## MEMORANDUM

**RE:** **Response to Comments**  
Proposed Coolidge Crossing  
84-86 Coolidge Street – Sherborn, MA

MDM Transportation Consultants, Inc. (MDM) has prepared the following responses to transportation-related comments as issued in a Tetra Tech dated January 14, 2021. To facilitate review, specific comments that require additional responses are paraphrased with corresponding responses.

**Figure 1**  
*Intersection Sight Distance Analysis*  
*The Villages at Sherborn*

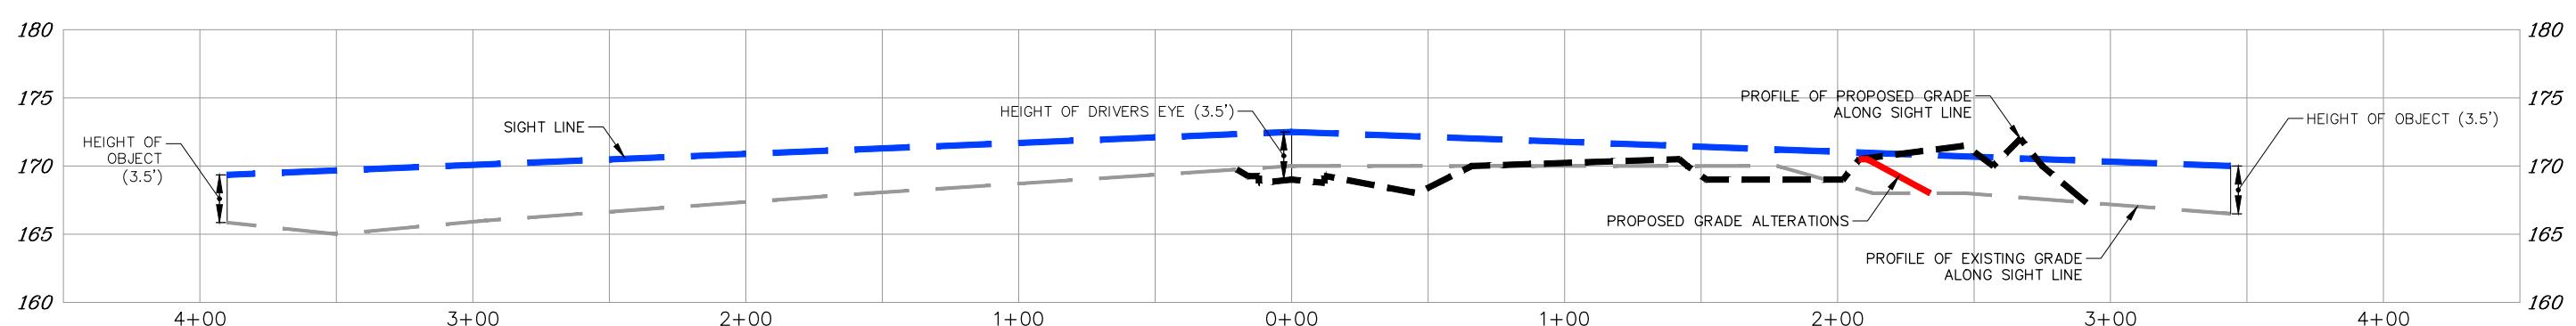
Comment T1: *"The TIAS presents Stopping Sight Distance (SSD) for both the posted speed limit (35 mph) and the observed 85th percentile speed (44 mph); however, Intersection Sight Distance (ISD) is only noted for the posted speed limit. Since the observed 85th percentile travel speeds are higher than the posted speed limit, TT recommends the Applicant include a discussion of the available ISD compared to the desired ISD using the observed travel speed. TT also recommends the Applicant confirm the SSD is listed in the appropriate directions in Table 4, as the available SSD eastbound and westbound appear to be reversed."*

Comment T2: “As currently shown on the Plan View in Figure 4, the Ideal ISD line is drawn through a wooded area on the site (looking left from the site driveway). There appears to be a number of large trees within that wooded area that may hinder the line of sight. The TIAS notes that the recommended sight lines will be satisfied “with selective clearing and grading as part of the installation of the Site driveway.” If any of the trees within the wooded area are to be removed, they should be noted on the plan. The sight triangles and area of clearing for the 44-mph observed speed should be shown on the plan.”

**Response:** The intersection sight distance shown in the September 2020 Traffic Impact and Access Study (TIAS) has been updated as shown in **Table R1** to reflect the minimum ISD for the observed 85<sup>th</sup> percentile speed and the ideal ISD for the regulatory speed limit along Coolidge Street with respect to the latest plan set prepared by Civil Design Group, LLC. Furthermore, the plan view and profile on the latest Site Plan is presented in **Figure 1** which indicates that the with a minor change in grading which MDM will continue to work with the Civil Design Group on as the site design evolves, the recommended sight line requirements from AASHTO will be satisfied.

**Response:** The large trees within the sight line areas will be inventoried and added to the final site plan set to be prepared by Civil Design Group, LLC. Likewise, the sight line triangles from the proposed site driveway looking onto Coolidge Street will be added to the final plan set.

## INTERSECTION CRASH RATE WORKSHEET

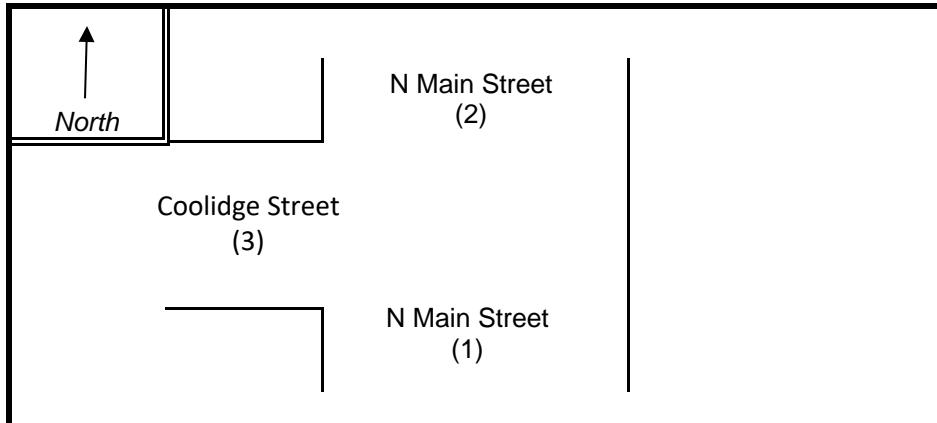
Comment T3: “The crash analysis has generally been prepared in accordance with industry standards and includes an evaluation of data from the MassDOT crash database for the study intersections for the five-year period between 2015 and 2019. However, the volumes included on the crash rate worksheets are inconsistent with the volumes presented in Figure 3. The results of the crash rate calculation with the volumes presented in Figure 3 do not change significantly, however, so no further action is required.”

**Response:** The crash rate calculations have been updated (see **Attachments**) to reflect the 2020 Baseline conditions. MDM concurs that no further action is required.

**Exhibit 1**  
*Conceptual Plan*  
*Shuttle Bus Turnaround*

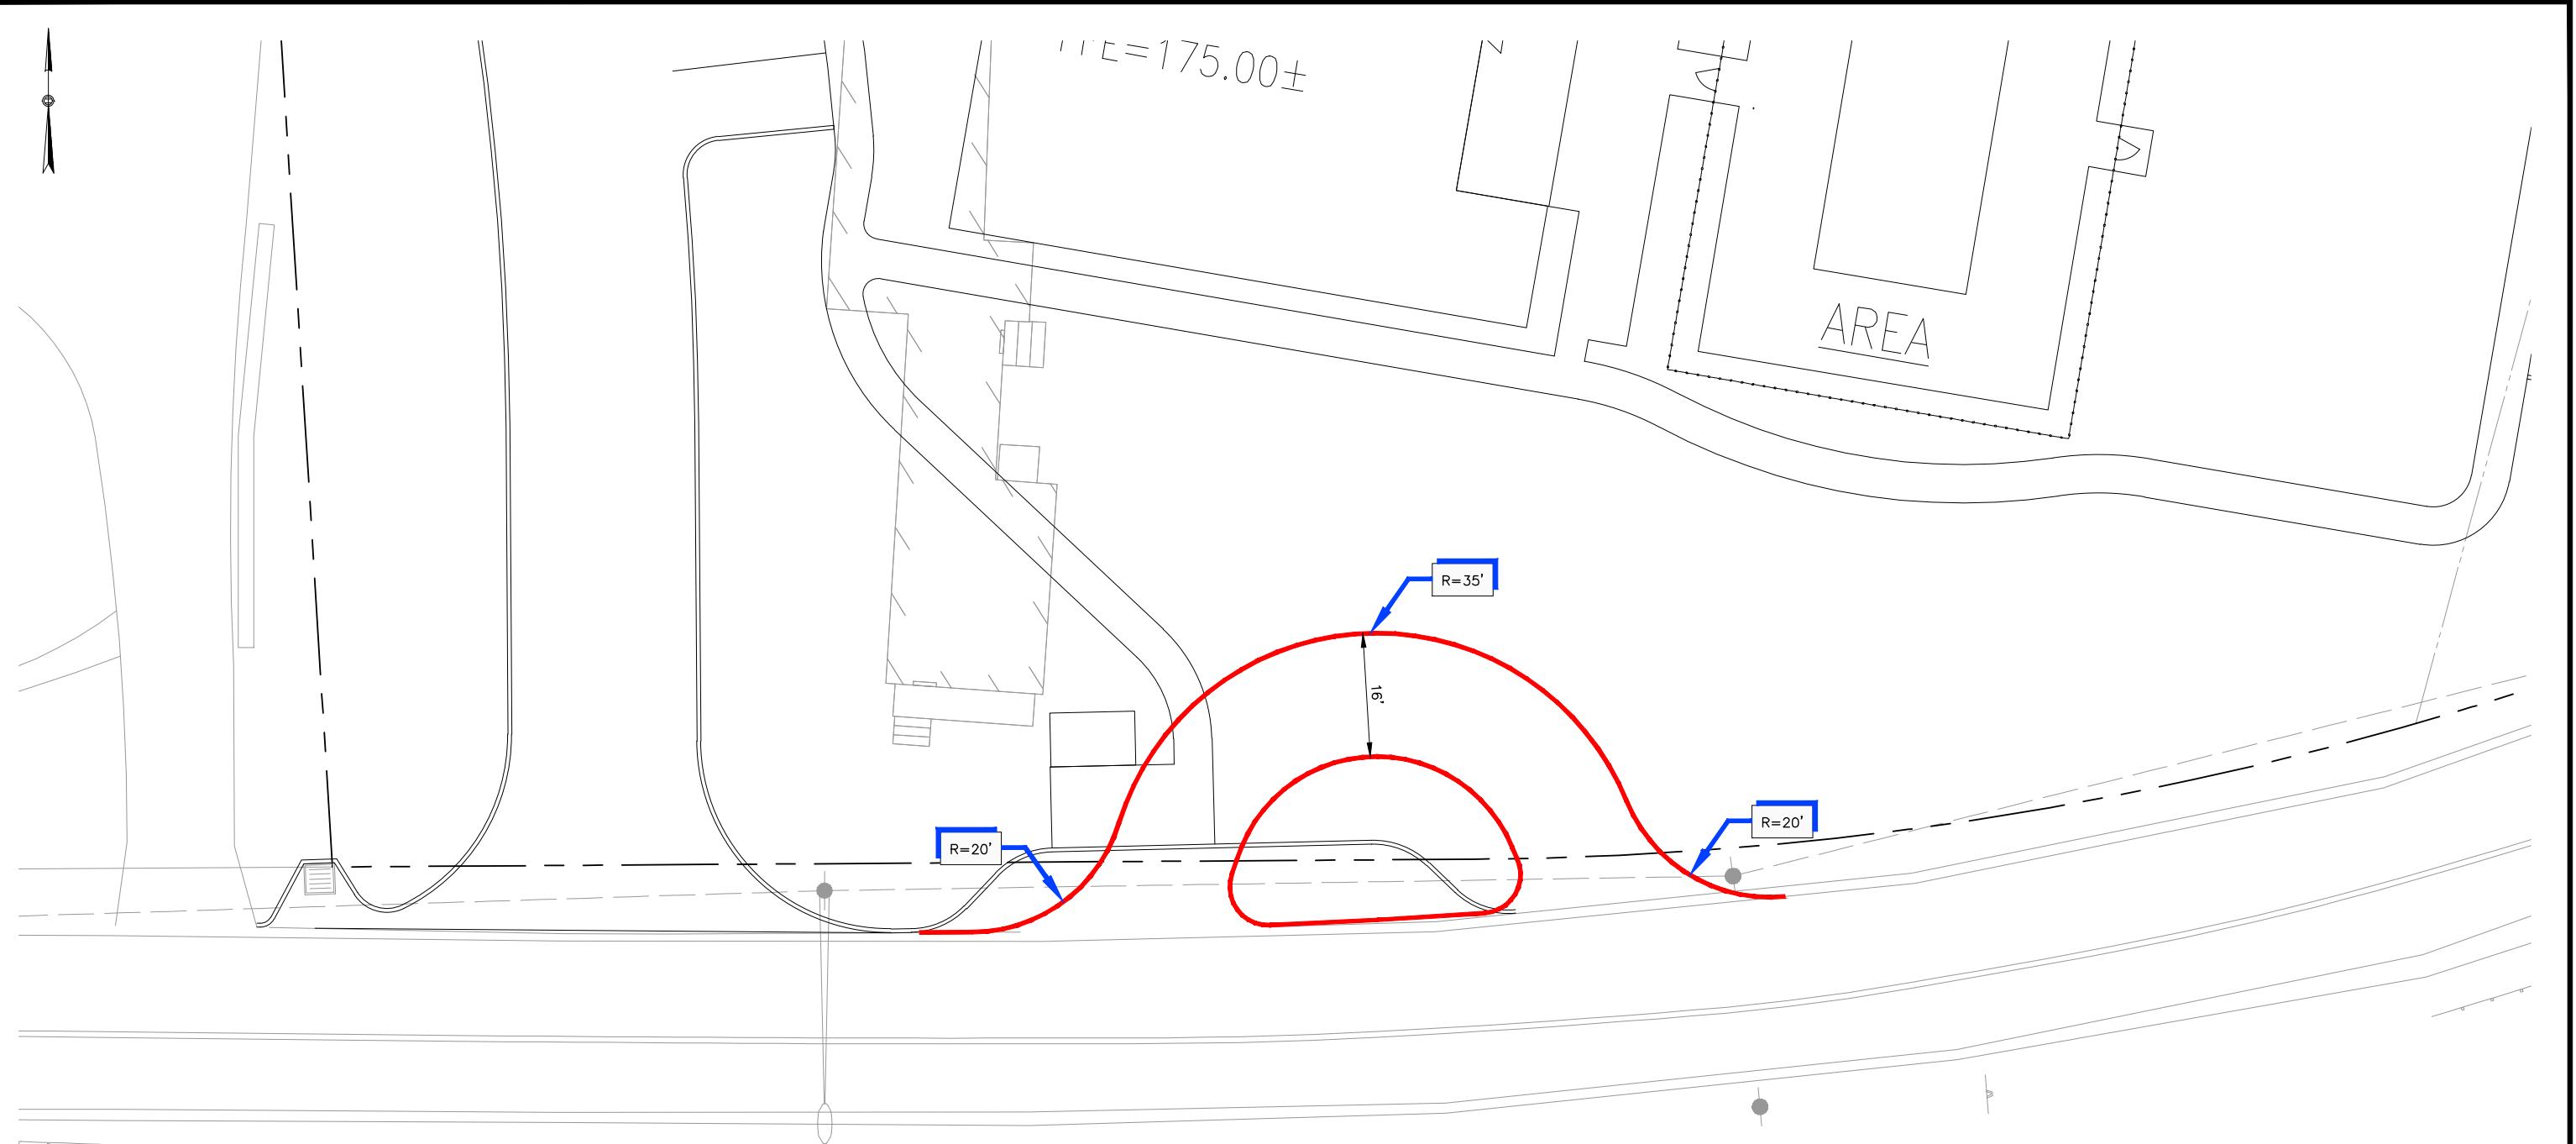
Comment T6: *"The Applicant shows a proposed bus shelter and pull-out just south of the site driveway. The shelter is to be located outside of the sight triangle. Since the ideal sight distance shown on Figure 4 was based on the posted speed limit and not the observed 85th percentile speed, this bus shelter may need to be relocated further back from the edge of the roadway to provide an adequate line of sight looking left from the site driveway. Additionally, the need for a bus pull-out is unclear at this location. There was no discussion of any transit in the TIAS. A school bus would be safer stopping directly in the roadway as the bus stops traffic in both directions with the use of the flashing red lights and STOP sign. TT recommends the Applicant clarify the need for this bus pull-out and the relocation of the bus shelter to be outside of the ideal ISD line based on the 85th percentile speed."*

**Response:** The proposed bus shelter and bus turn around area has been designed to accommodate a MWRTA shuttle bus (see **Attachments** for Concept Plan and AutoTurn Exhibit). If MWRTA agrees to extend bus service for bus routes 10 and 11 or another route to the Site, then the turnaround area will be constructed. The shuttle bus would arrive from the northwest from Speen Street travel to the Site along Coolidge Street and then use the turn around to reverse direction back to Speen Street to continue its designated route. MDM concurs and as presented at the December 10, 2020 ZBA hearing for the project the school bus per policy will stop within the travel lane and use their flashing red light and STOP sign; therefore, the turnaround area has not been designed for a school bus. The bus shelter is located outside the sight line area.
